REACTIVITY CONTROL SYSTEMS

3/4.1.3 MOVABLE CONTROL ASSEMBLIES

ST. LUCIE - UNIT 1

Amendment No. 27

Figure 3.1-1a Allowable Time to Realign CEA vs. Initial Fr^T

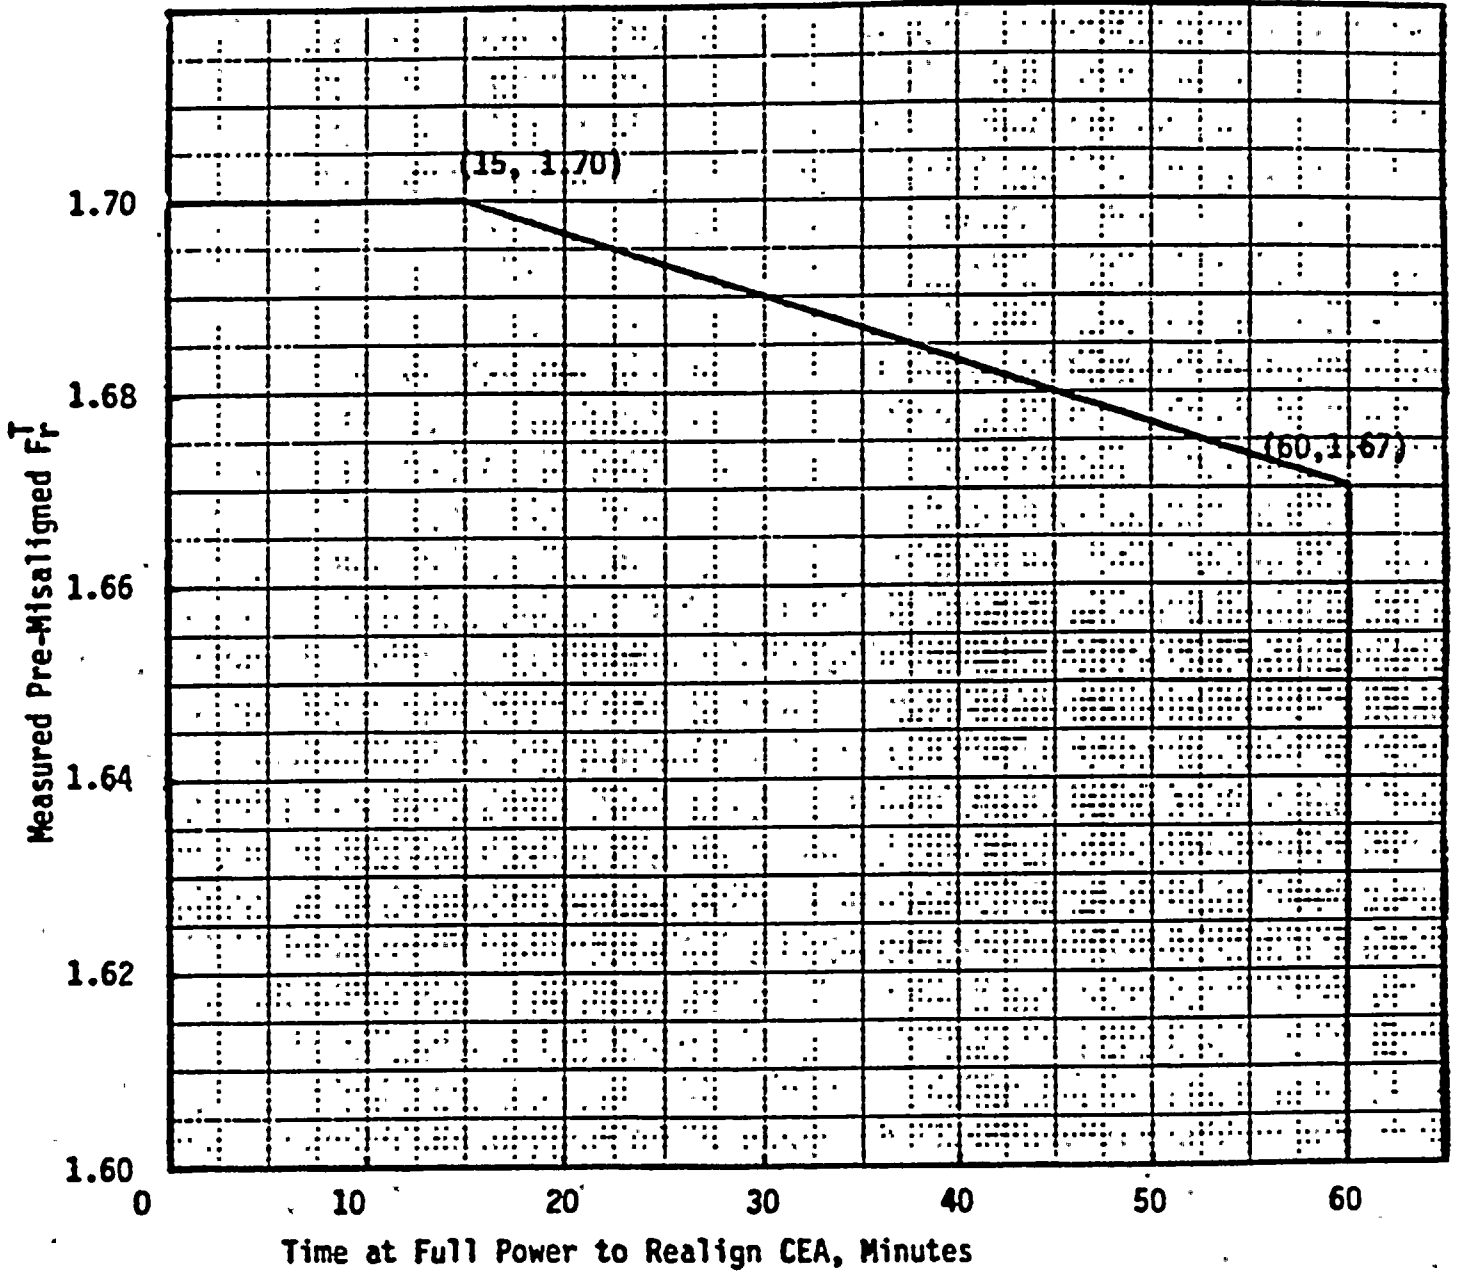
OR MORE INCHES, OPERATION IN MODES 1 & 2 MAY CONTINUE PROVIDED THAT THE MISALIGNED CEA IS POSITIONED WITHIN 7.5 INCHES OF THE OTHER CEAs IN ITS GROUP IN ACCORDANCE WITH THE TIME CONSTRAINTS SHOWN IN Figure 3.1-2.

- f) WITH ONE FULL-LENGTH CEA MISALIGNED FROM ANY OTHER CEA IN ITS GROUP BY 15 OR MORE INCHES BEYOND THE TIME CONSTRAINTS SHOWN IN Figure 3.1-2 reduce power to $\leq 70\%$ of RATED THERMAL POWER prior to completing ACTION f.1 or f.2

THE REQUIREMENT TO REDUCE POWER IN CERTAIN TIME LIMITS DEPENDING UPON THE PREVIOUS F_T^T IS TO ELIMINATE A POTENTIAL NONCONSERVATISM FOR SITUATIONS WHEN A CEA HAS BEEN DECLARED INOPERABLE. A worst case analysis has shown that a DNBR SAFDL VIOLATION MAY OCCUR DURING THE SECOND HOUR AFTER THE CEA MISALIGNMENT IF THIS REQUIREMENT IS NOT MET. THIS POTENTIAL DNBR SAFDL VIOLATION IS ELIMINATED BY LIMITING THE TIME OPERATION IS PERMITTED AT FULL POWER BEFORE POWER REDUCTIONS ARE REQUIRED. THESE REDUCTIONS WILL BE NECESSARY ONCE THE DERATED CEA HAS BEEN INOPERABLE. THIS TIME ALLOWED TO CONTINUED OPERATION AT A REDUCED POWER LEVEL CAN BE PERMITTED FOR THE FOLLOWING REASONS:

1. THE MARGIN CALCULATIONS WHICH SUPPORT THE Technical Specifications ARE BASED ON A STEADY-STATE RADIAL PEAK OF $F_T^T > 1.70$.
2. WHEN THE ACTUAL $F_T^T \leq 1.70$, SIGNIFICANT ADDITIONAL MARGIN EXISTS
3. THIS ADDITIONAL MARGIN CAN BE CREDITED TO OFFSET THE INCREASE IN F_T^T WITH TIME THAT CAN OCCUR FOLLOWING A CEA MISALIGNMENT.
4. THIS INCREASE IN F_T^T IS CAUSED BY XENON REDISTRIBUTION.
5. THE PRESENT ANALYSIS CAN SUPPORT ALLOWING A MISALIGNMENT TO EXIST FOR UP TO 60 MINUTES WITHOUT CORRECTION, IF THE INITIAL $F_T^T \leq 1.67$.
